Guardians of the Bays Comment on the Wellington International Airport Southern Seawall Renewal

- 1.3 The comments below relate to the [*Wellington International Airport Limited Southern Seawall Renewal Fast Track Approvals Act – Substantive Application 23 October 2025*](#)-that relate to the:

Replace and upgrade the existing seawall at the southern end of the runway at Wellington Airport, and carry out activities to support reconstruction, including a new or upgraded supply wharf and construction yards.

Figure 2.6: Existing Southern Seawall including seawall elements (Beca, 2025a). 5

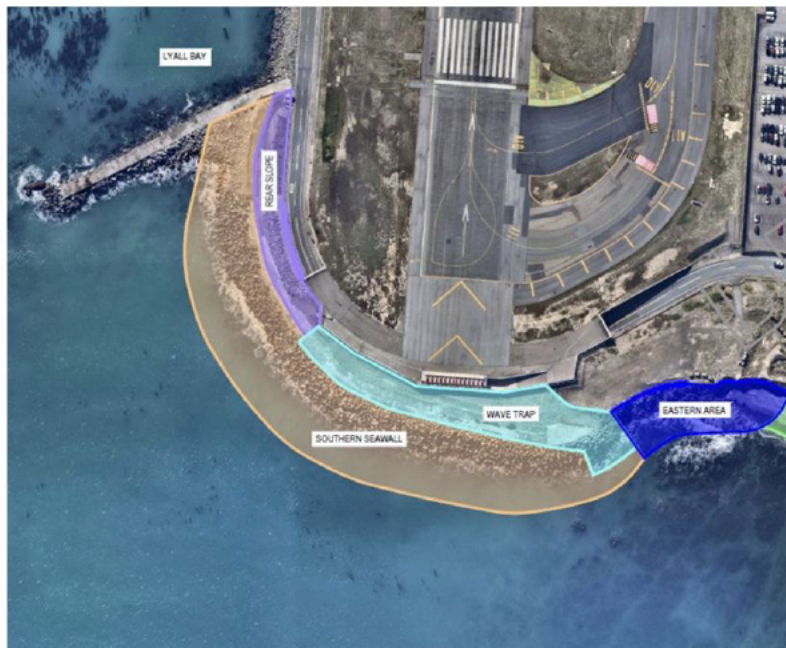
- 1.11.1 Erosion that is occurring at the western end of Moa Point beach (eastern end of the southern seawall). A small portion is being reconstructed in this project but the rest of the beach will remain in an increasing eroded state. Will the wave effects and combined storm wave and rain-water that will run off from the wave trap (Figure 2.6 above) of this project increase the erosion of the western end of Moa Point beach?

Attachment G

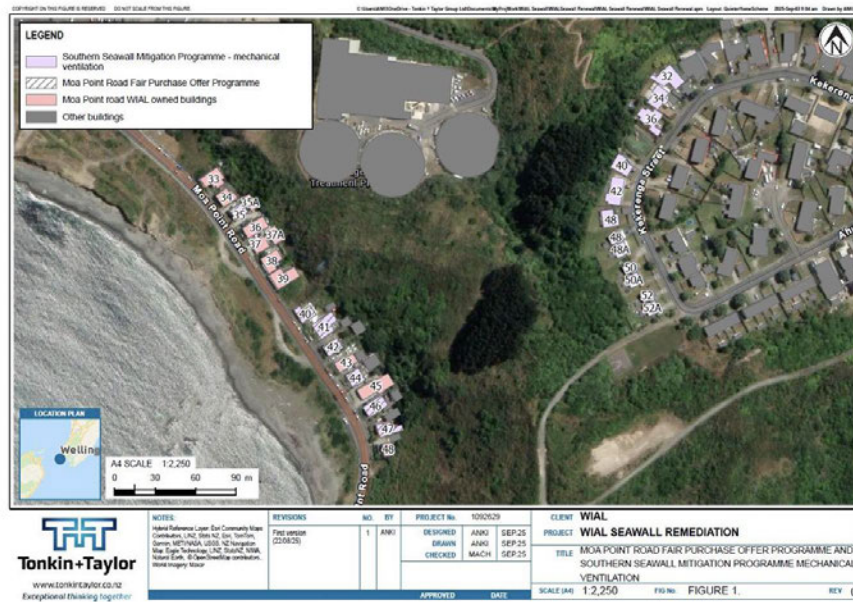
GOTB is concerned that it is not just mechanical ventilation systems residences require but also double glazing. GOTB recommends double glazing is also offered to the 19 owners of properties that will be affected by the noise.

Fig. 2.1. Annual cycle of the kororā. Timing of events in the annual cycle varies between locations, and varies between years at each kororā location.

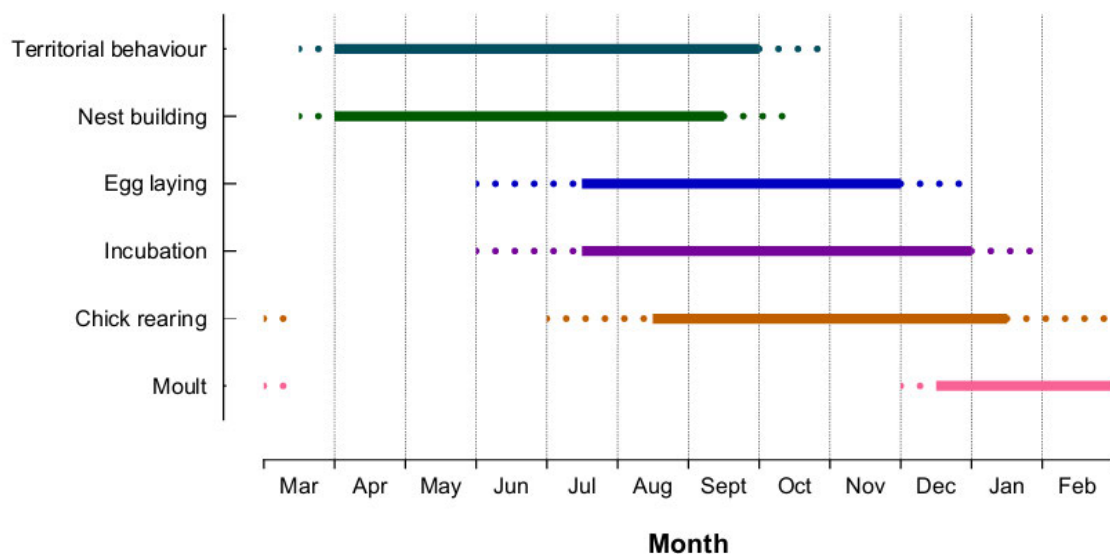
The annual cycle of Kororā (Figure 2.1 Draft -Penguin Management-plan for Southern Seawall Renewal January 2026) would suggest that Kororā will be present along the southern seawall throughout the year. Number of Kororā increase in autumn and Winter where between July to December they are breeding and December to February they are moulting.
